January 2011 Flood Event: Report on the operation of Somerset Dam and Wivenhoe Dam

REVIEW OF HYDROLOGICAL ISSUES

- Final A
- 11 March 2011

Sinclair Knight Merz
ABN 37 001 024 095
Floor 11, 452 Flinders Street
Melbourne VIC 3000
PO Box 312, Flinders Lane
Melbourne VIC 3000 Australia
Tel: +61 3 8668 3000
Fax: +61 3 8668 3001
Web: www.skmconsulting.com

Figure 2.1 Estimates of rainfall totals to 8:00am 11 January 2011 (sourced from www.bom.gov.au during the event).

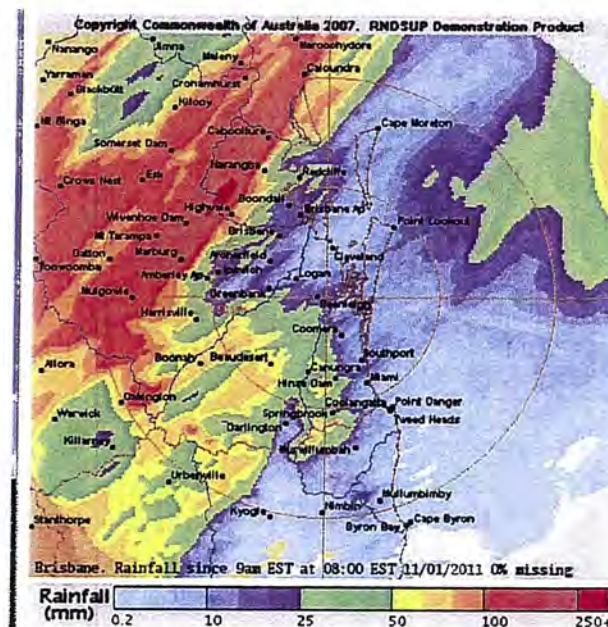
It would appear that the locations of the rainfall gauges are biased towards the valley floors. This is not uncommon as it is difficult to install and maintain gauges in remote areas at high elevations. While this bias will tend to yield estimates of catchment rainfalls that are lower than actual, in practice this need not lead to the floods being underestimated as the models are generally calibrated to take this bias into account.

From radar imaging available during the event and inferences from the water level data in Wivenhoe Reservoir, it is believed there was substantial rainfall in the vicinity of the reservoir on the morning of 11 January that was not reflected in the telemetered data. It is understood that additional rainfall stations are being installed which will increase the density of rainfall coverage, however there will always be the possibility that significant rainfall may occur between stations. Inevitable gaps in the rainfall networks can be mitigated by incorporating information from weather radar during an event. For example, Figure 2.1 shows the 24 hour rainfall depths to 8:00am

on 11 January 2011 estimated from the weather radar operated by the Bureau of Meteorology. This image was captured from the Bureau of Meteorology web site during the event and does not reflect the outcome of any quality control measures and verification against recorded point rainfalls that may have occurred subsequently. The radar image shows the high rainfalls in the vicinity of the Wivenhoe Reservoir that were not captured by the ALERT gauges. Although there still remains uncertainty in radar rainfall estimates, such information (as discussed in Section 8.9 of the Seqwater report) can be used in at least a qualitative manner to help inform the interpolation between point estimates of rainfall.

Figure 4.1 Comparison of eight day rainfall totals recorded by Seqwater and Bureau of Meteorology gauges to 13 January 2011.

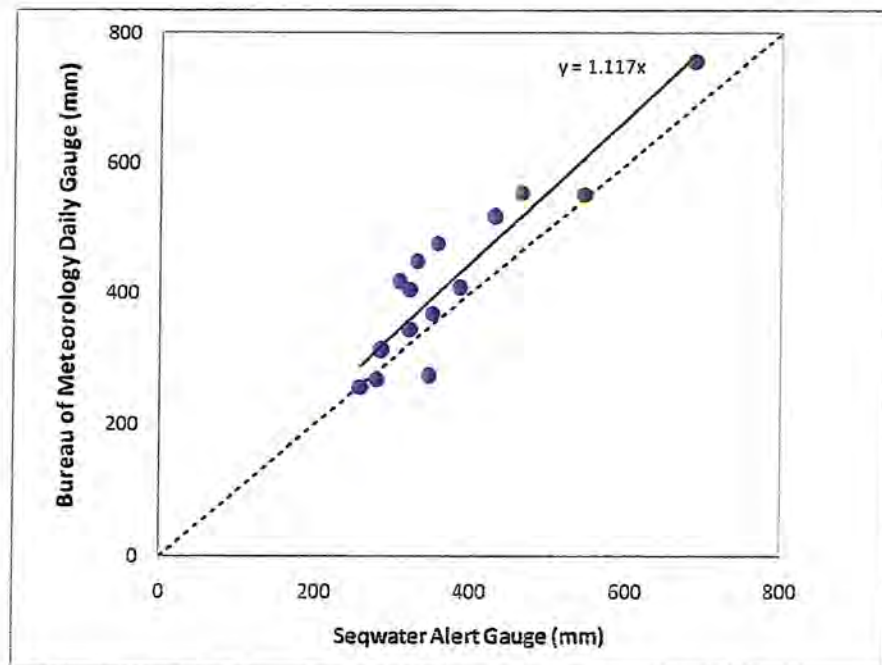
Generally the daily read gauges are not at the same location as the ALERT stations. In order to compare the data, daily read gauges located within two km of the ALERT stations were identified. The total rainfall recorded at each pair of sites was then compared for the eight days to 13 January 2011.

Figure 4.1 below shows that there is generally good agreement in the rainfall totals at the pairs of stations. There appears to be a small bias with the daily read values approximately 10% higher than the ALERT values. The reason for this relatively small bias was not explored but could possibly be attributed to the tendency for the ALERT gauges in the lower rainfall portions of the catchment. However, given the close proximity of the station pairs the difference it is speculated that the most likely reason for the bias might be due to differences in standard installation details (such as distance from the ground and exposure of the site).

The generally good agreement between the ALERT and daily read data confirms that the ALERT data is appropriate to support flood operations decision making in real time. In real time the tendency of the ALERT data to slightly underestimate the rainfall totals when compared to the daily gauges is compensated by the progressive calibration of the loss model during the event, and by closing the water balance at the reservoir itself.

Figure 4.2 Progressive comparison of 24 hour catchment average Quantitative Precipitation Forecasts versus actual values.

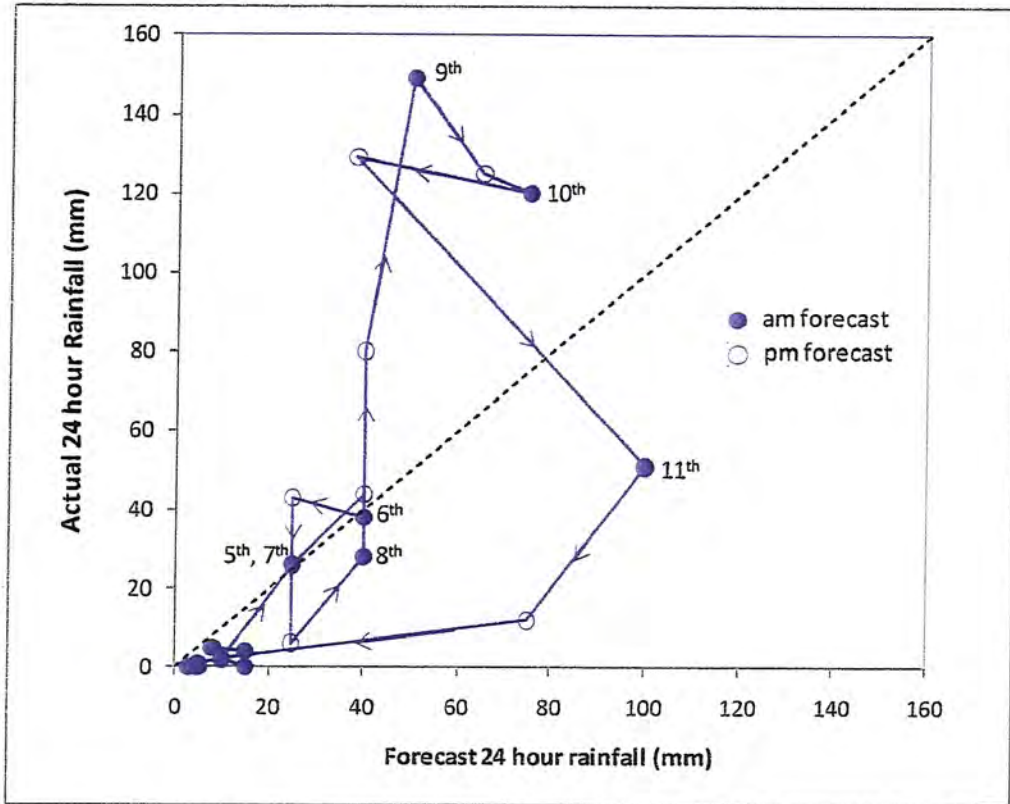
The performance of the 24 hour catchment average Quantitative Precipitation Forecasts provided by the Bureau of Meteorology is illustrated graphically in Figure 4.2. It is seen that the forecasts leading into the first and second major flood peaks (morning of the 9th and afternoon of the 10th) were around one third the actual. The forecast following the second peak (on the 11th) were around twice the actual.

Figure 4.3 Progressive comparison of forecast versus actual 24 hour spatial rainfall distribution.

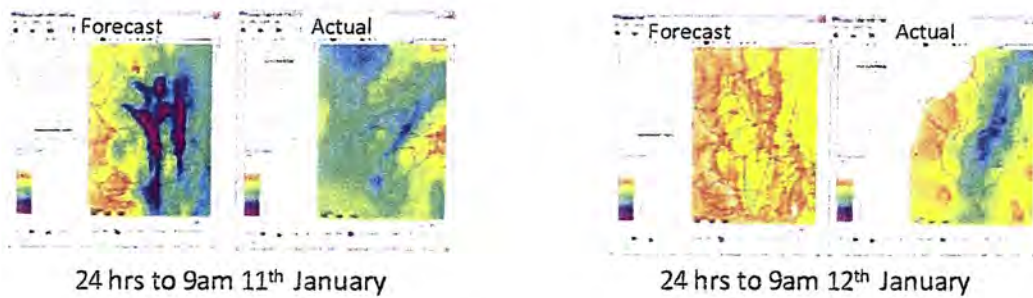
In terms of spatial accuracy, it is seen in Figure 4.3 (from Seqwater Appendix J) that the 24 hour forecast made at 9am on the 10th does indicate very heavy rainfall over the Stanley catchment and in the immediate vicinity of Wivenhoe Dam. However the 24 hour forecasts for 9am on the 11th does not pick up the heavy rain in the immediate vicinity of Wivenhoe (which supports the inference discussed in the previous section regarding the sharp rise in reservoir level).

Figure 4.3 Progressive comparison of forecast versus actual 3-day and 5-day rainfall totals.

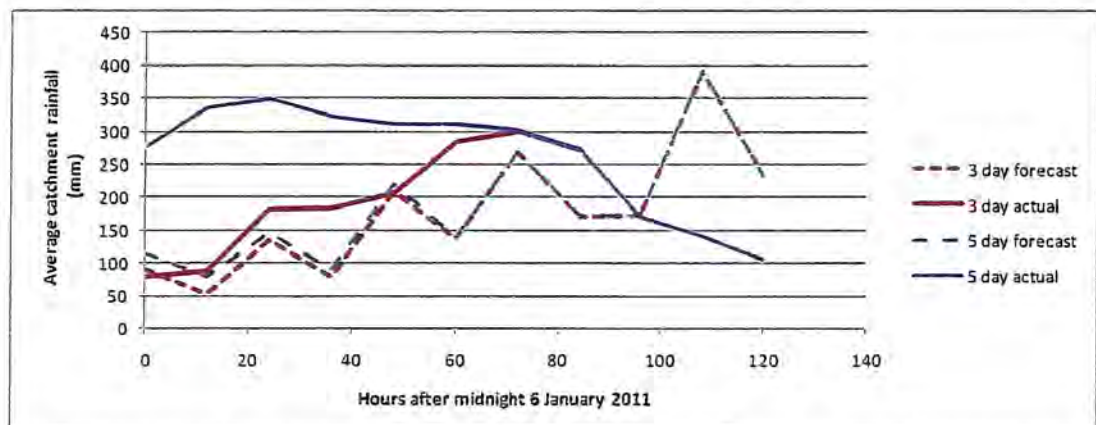
The performance of the 3-day and 5-day forecasts based on the ACCESS model is also discussed in the Seqwater report. The ACCESS model was jointly developed by the Bureau of Meteorology and the CSIRO, and incorporates modelling components developed by leading overseas climate agencies. A plot of the information provided is shown in Figure 4.3, which clearly illustrates the persistent underestimation of the larger catchment rainfalls in the period prior to the major flood peaks.

Figure 4.3 also highlights two features of particular interest:

- The difference between the 3-day and 5-day ACCESS forecasts is negligible throughout the event, which indicates that the rainfall was always expected to fall predominately within a 72-hour period; and,
- The successive forecasts fluctuate around a mean trend prediction by an alternating divergence of around 30% – there is little apparent persistence between successive forecasts which is not consistent with physical reasoning.

Figure 4.4 Forecast streamflows undertaken at 7pm on the 9th and 4am on the 11th January.

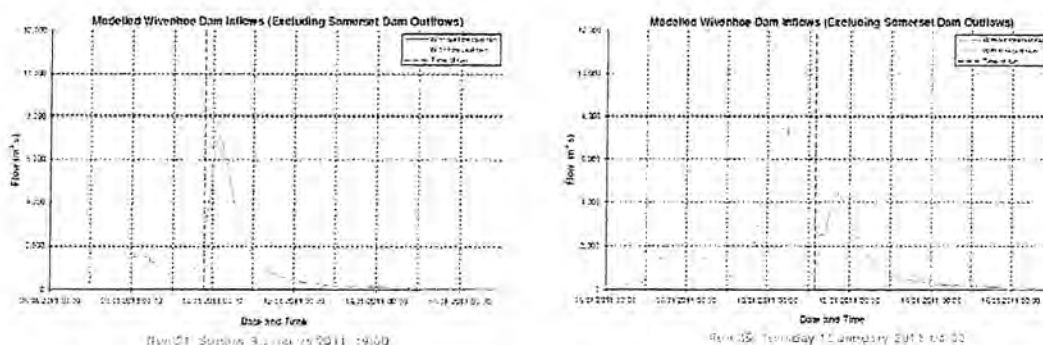
- Run 21, undertaken Sunday 9th January at 7pm
- Run 35, undertaken Tuesday 11th January at 4 am.

With respect to Run 21, the model predicted an inflow peak of around 8,800 m³/s, which is only about 5% lower than the computed peak (Table in Section 9 of the Seqwater report); the timing of the peak was correctly forecast to be some 12 hours later. It is assumed that the forecast was made using the 24 hour rainfall forecast that was around 50% lower than what actually occurred.

With respect to Run 35, the model predicted the second inflow peak of around 6,000 m³/s, which is around 55% lower than the computed peak; the timing of the peak was forecast to be some 14 hours later, which is a little later than what actually occurred. It is worth noting that the streamflow forecast was made when the previous 24 hour rainfall forecast was around 30% less than what actually occurred.

It is hard to see how these forecasts could be improved upon. In both cases the streamflow gauges further upstream in the catchment had only just commenced to rise again after the previous flood recession. The model is integrating the upstream flows that were recorded and routing them downstream to the reservoir, and there is insufficient forecast rainfall to magnify the flood response.

Figure 5.1 Spatial analysis of exceedance probabilities of 48 hour rainfalls.

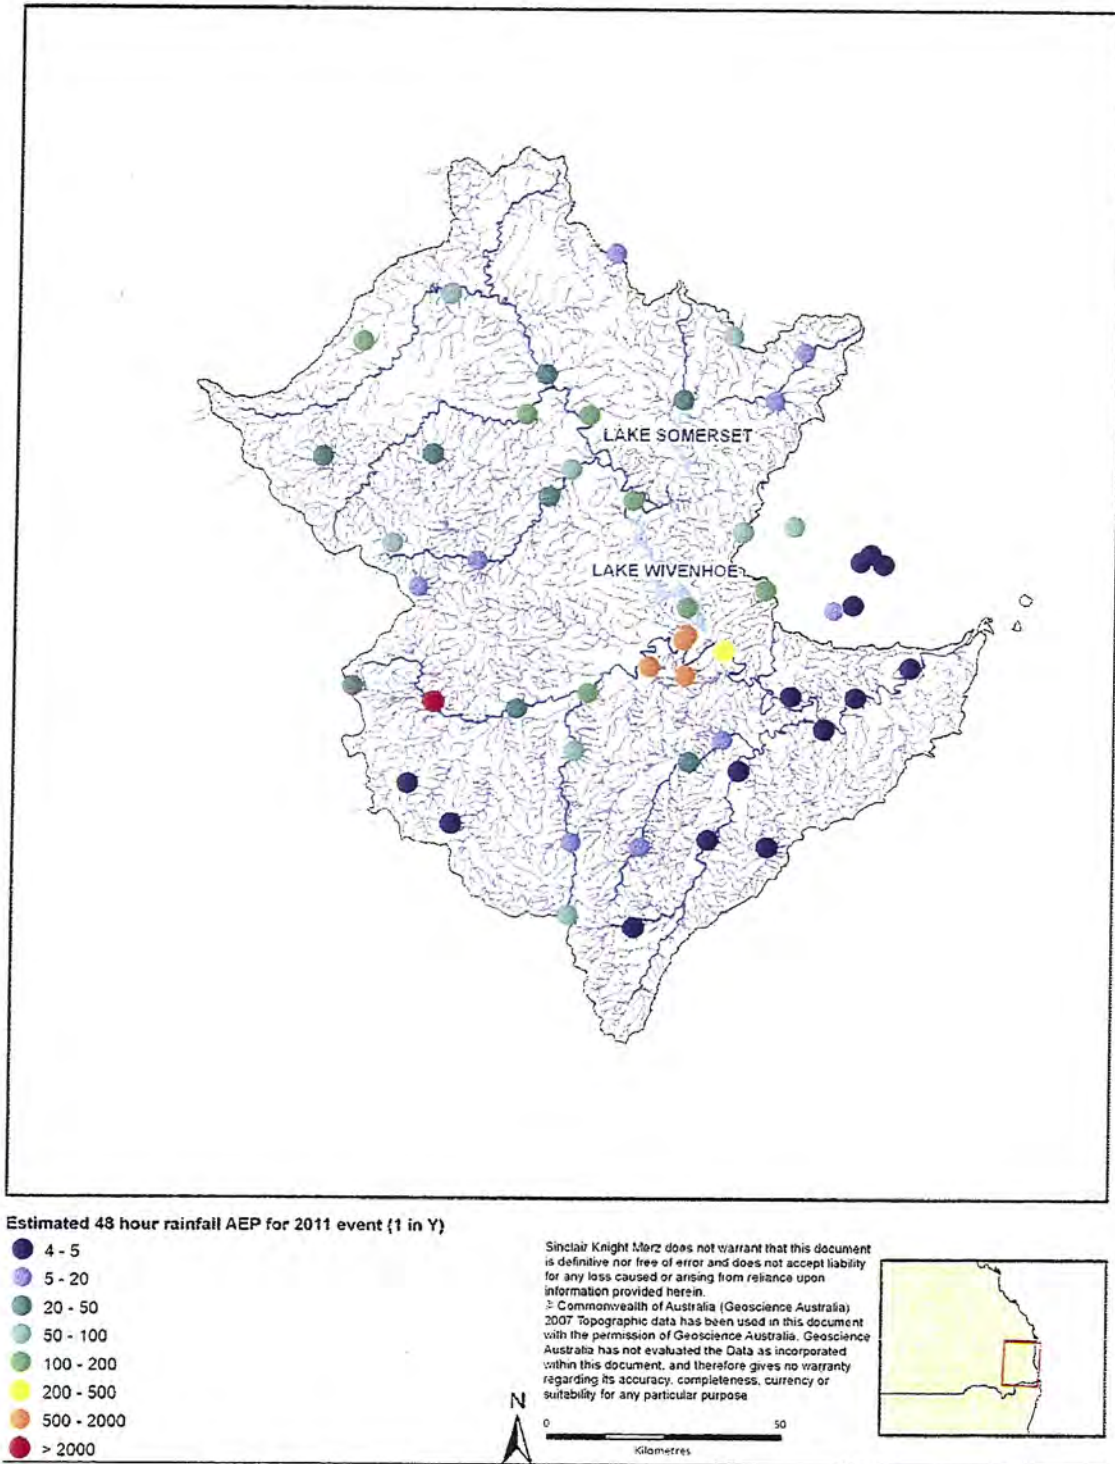
On the basis of Figure 5.1 it may be inferred that:

- The most extreme point rainfalls occurred in the centre of the Brisbane River catchment, in the areas immediately below Wivenhoe Dam – the annual exceedance probability of these rainfalls are between 1 in 500 and 1 in 2000;
- The annual exceedance probability of point rainfalls varies between around 1 in 20 at the upper reaches of the catchment above Wivenhoe Dam, to beyond 1 in 100⁺ in the lower reaches; and,
- The most intense region of localised rainfall occurred in the headwaters of the Lockyer Valley.

The above information is consistent with the exceedance probabilities of the catchment average rainfalls presented in Figure 8.4.2 of the Seqwater report (as derived using CRC-FORGE information). On this basis, it seems reasonable to assume that the annual exceedance probability of the catchment average rainfalls upstream of Wivenhoe Dam is between 1 in 100 and 1 in 200.
